### KIRRAWEE BRICK PIT - 75W MODIFICATION REVIEW

Assessment of Proposed Amended Concept  
Plan

Approved DA Plan (content supplied by AECOM)

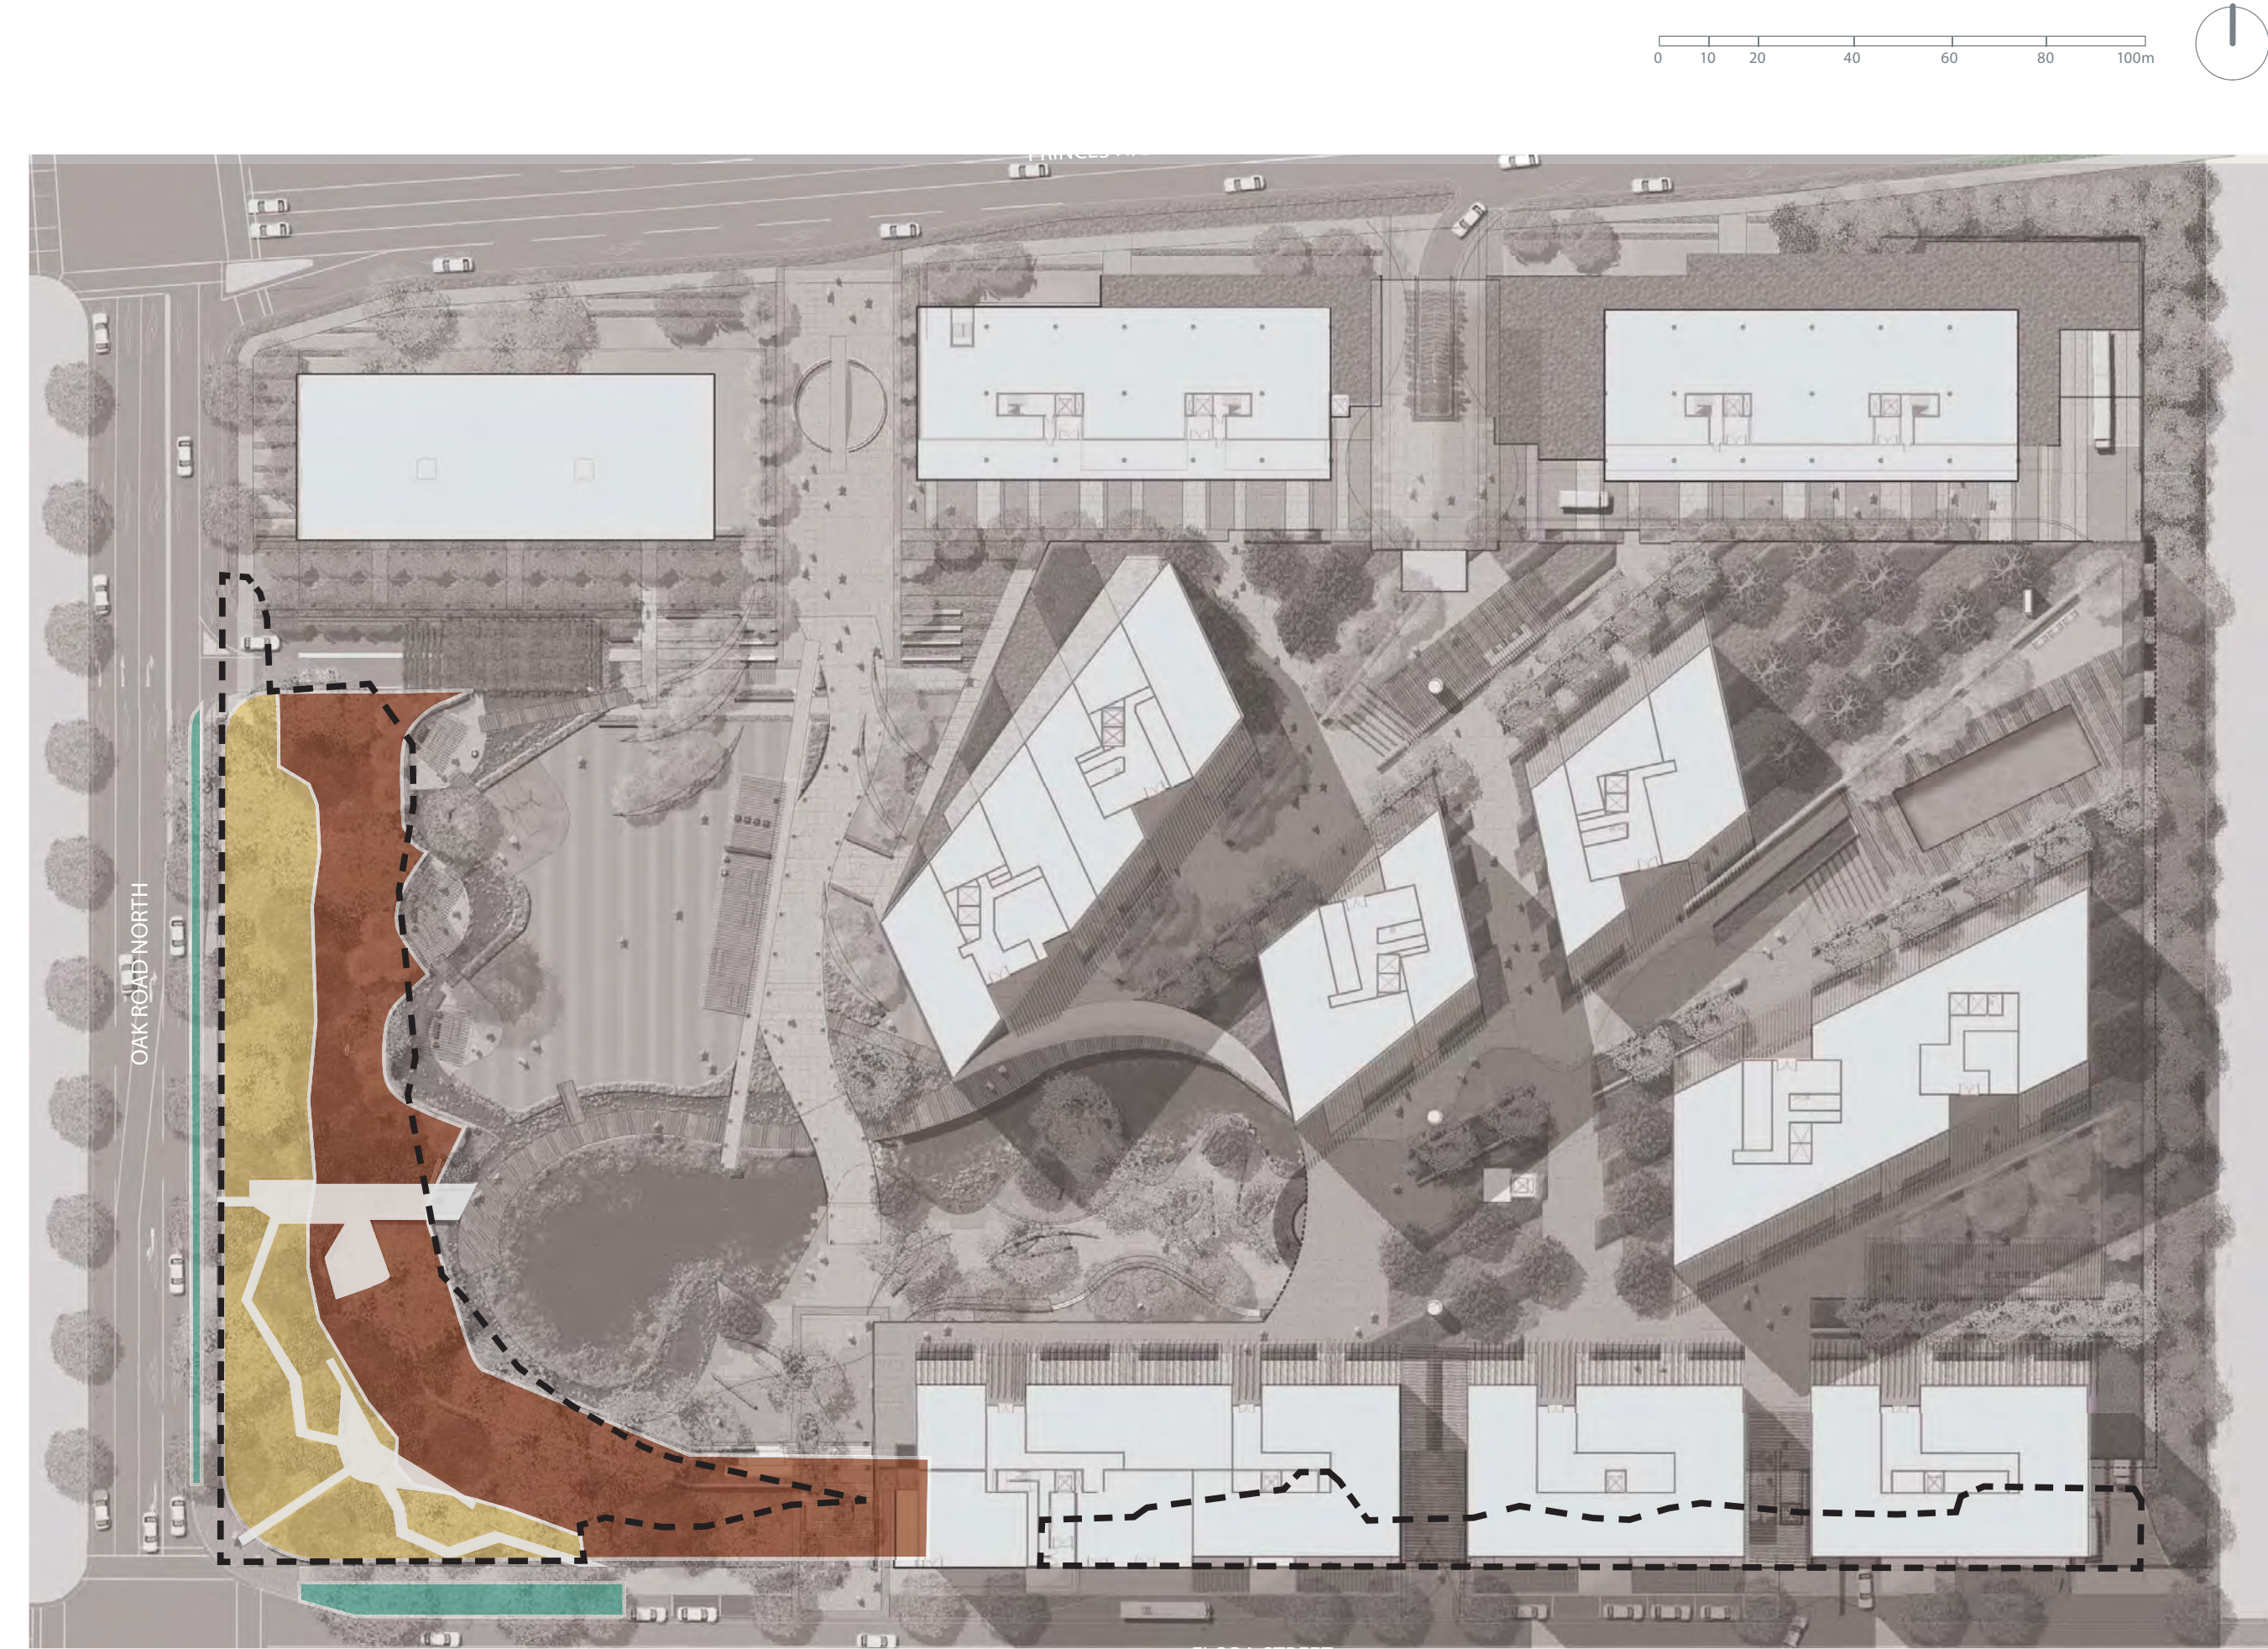
Approximately 4,766 m<sup>2</sup> of STIF currently occur on the subject site, and the approved Concept Plan would result in the removal of approximately 3,296 m<sup>2</sup> of this community. According to the amended Concept Plan, approximately 3,242 m<sup>2</sup> of this community will be removed, which constitutes a reduction of approximately 54 m<sup>2</sup> of this community that is required to be removed (or an increase of approximately 54 m<sup>2</sup> in the area of original STIF that would be retained on the subject site).

Due to the removal of approximately 3,296 m<sup>2</sup> of STIF, the approved Concept Plan required 6,592 m<sup>2</sup> of compensatory planting (2:1 ratio). Of this, approximately 1,693 m<sup>2</sup> of STIF was proposed to be provided on-site on re-graded batters and a further 5,300 m<sup>2</sup> was to be provided in off-site plantings. This provided a total of 6,993 m<sup>2</sup> of compensatory plantings.

Proposed Landscape Plan\_Impact of STIF

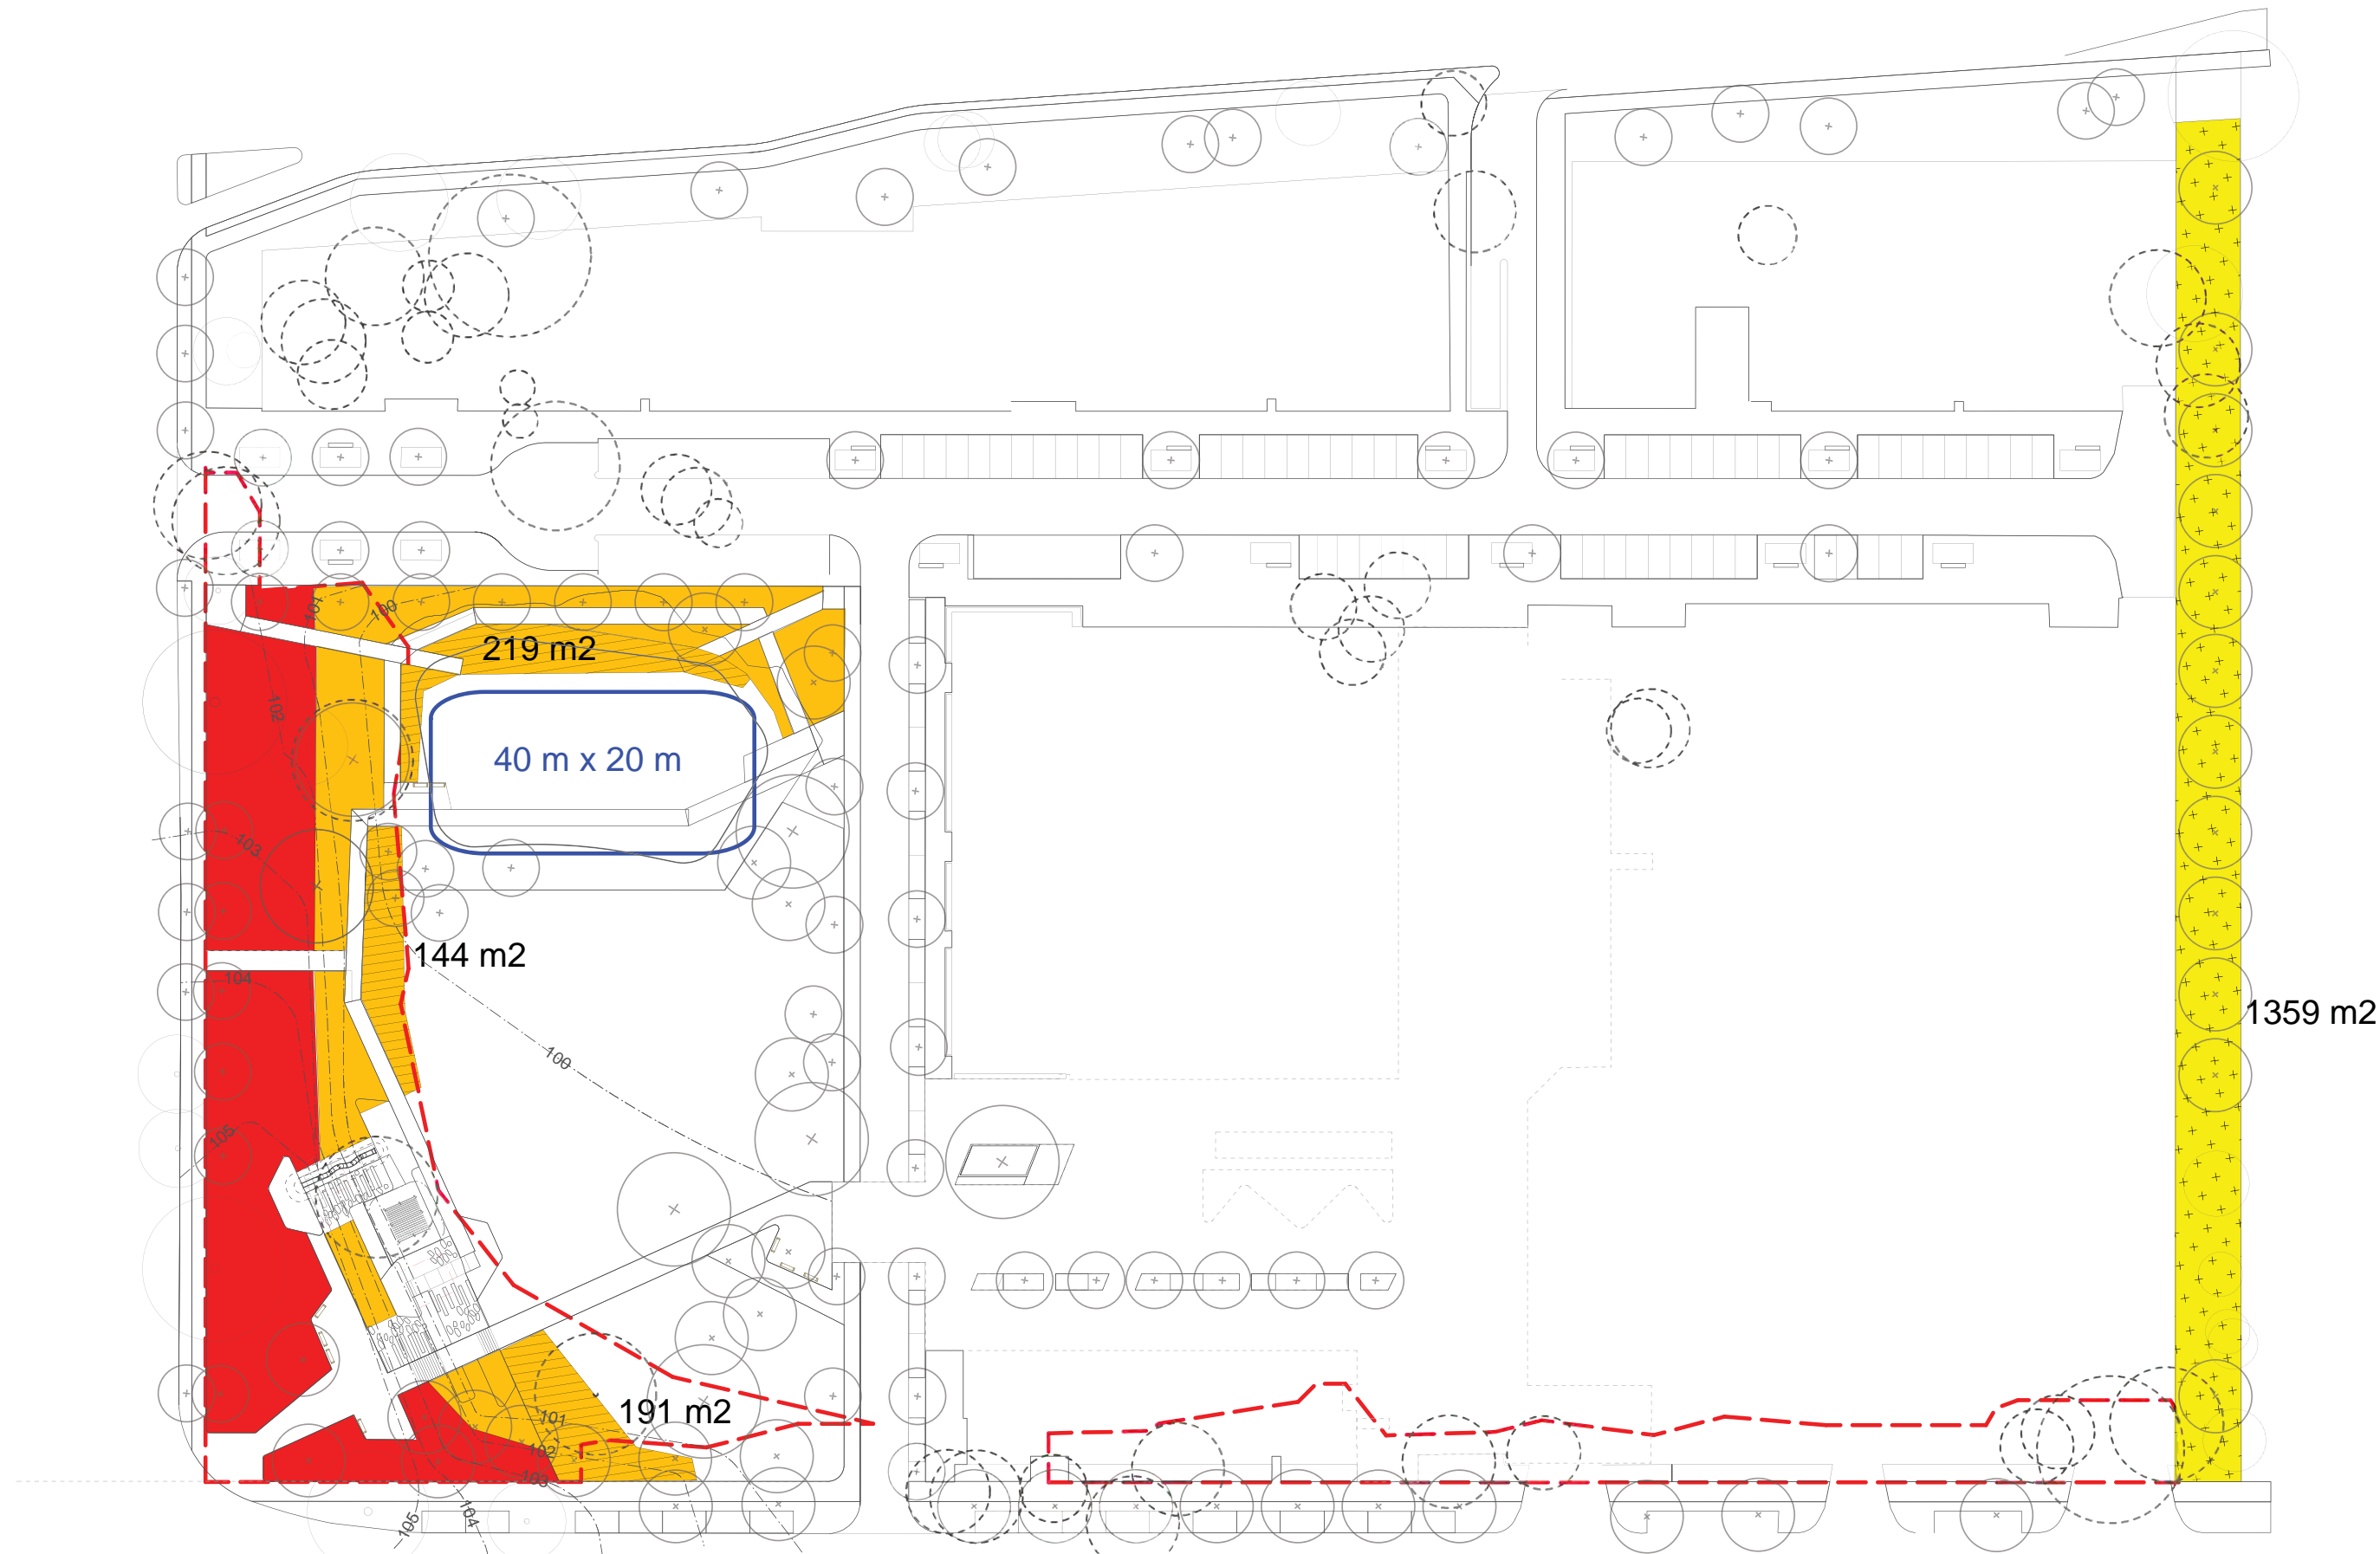
The amended Concept Plan proposes to remove approximately 3,242 m<sup>2</sup> of STIF, and therefore requires 6,482 m<sup>2</sup> of compensatory plantings (2:1 ratio), which is a reduction of 110 m<sup>2</sup>. The amended Concept Plan proposes to plant a total of 2,785 m<sup>2</sup> of STIF on the site, made up of 872 m<sup>2</sup> on re-graded soil batter, as well as additional areas of STIF within the park and on the eastern boundary (554 m<sup>2</sup> and 1,359 m<sup>2</sup> respectively). In addition, approximately 3,697 m<sup>2</sup> of offsite plantings is proposed for the amended Concept Plan. In total, approximately 6,482 m<sup>2</sup> of compensatory plantings are proposed to be provided under the proposed Concept Plan, which is equivalent to a 2:1 ratio of STIF cleared to that replanted. This is in accordance with the agreed compensation measures for the removal of STIF, and is appropriate to compensate for the removal of some areas of this community.

Although the ultimate outcome in terms of amount of STIF that will exist after the development is complete is similar between the approved Concept Plan and the proposed amended Concept Plan, there are some key differences. These relate mostly to the amount of on-site versus off-site plantings that are proposed. The approved Concept Plan proposed to plant approximately 1,693 m<sup>2</sup> of STIF on the subject site compared to approximately 2,785 m<sup>2</sup> under the proposed amended Concept Plan. This is an increase of approximately 1,092 m<sup>2</sup>. This is considered to be a better ecological outcome, as it replaces SSTF closer to where it will be removed and will directly benefit the species impacted by the removal of SSTF on the subject site. This will also assist in maintaining genetic integrity of this occurrence of SSTF and will increase the area of this community in the subject site.
